ADDENDUM NO. 1

RE: Greenaway Drain Enclosure

Project No. 17-019

FROM: Boss Engineering, on behalf of

END SECTION AND BAR SCREEN DETAIL NO SCALE

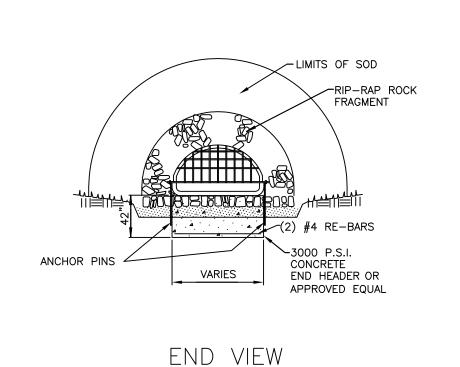
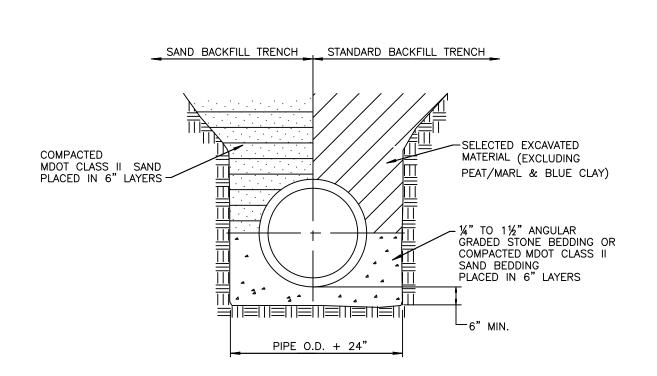
This Addendum shall be considered when bidding the subject project. Existing concrete flared end sections were recently installed and may be reusable. If they are not usable, alternative Work and related bid items may be required. As such, the following items may be necessary to complete the Work. Provide separate bids for:

<u>Description</u>	<u>Unit</u>	<u>Quantity</u>	<u>Unit Price</u>	Bid Price
Remove Exist. 42" Concrete Flared End Section	EA	1		
Remove Exist. 12" Concrete Flared End Section	EA	2		
42" Concrete Flared End Section	EA	1		
12" Concrete Flared End Section	EA	1

Prospective bidders should review the site, determine condition and usability of existing concrete end sections prior to bid submittal. Should any or all of the above items be necessary to complete the Work, they would replace related items from the original bid.
